Reposition Forward Junction Box HV Cables

Classification	Campaign Bulletin	Section/Group	44 - High Voltage System	Country/Region	Europe, APAC
Year	2016	Model	Model S	Version	RHD RWD

Figure 1

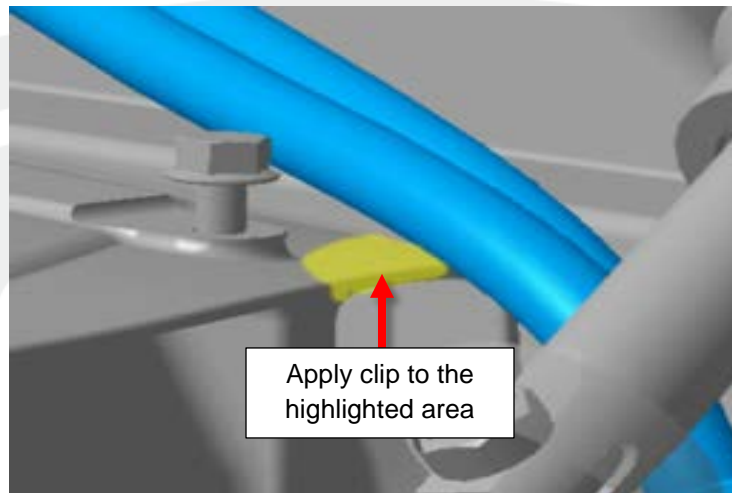
1. Remove the underhood storage unit (refer to Service Manual procedure 15242301).
2. Inspect the fabric harness tape on the forward junction box HV cables:
 - If any part of the tape is penetrated or worn through, replace the HV cables and continue this procedure.
 - If no damage is present, continue this procedure.
3. Secure the edge clip to the top of the front rail extension (Figure 1).

Figure 2

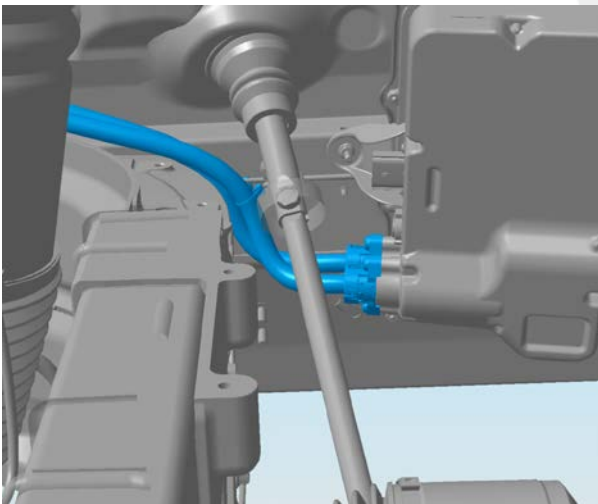
4. Route the HV cables so that they bend away from the shaft (Figure 2), then secure them with the cable tie (Figure 2).
